AT&T  
585-350-402

**CONVERSANT®**  
**Voice Information System**  
**Version 4.0 Change Description**

# Version 4.0 Change Description

**Figure 1. ARU Switch Settings for DSW1 and DSW2**

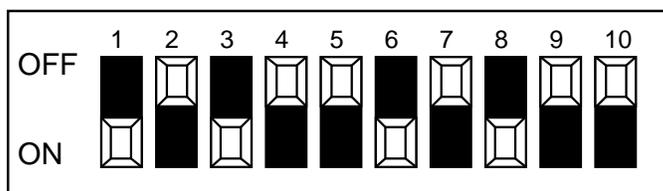
- In Chapter 2 of *CONVERSANT VIS CompuLert/SCCS*, 585-350-808, the figure depicting the switch setting is incorrect. Use the figure below instead of the figure in the book:
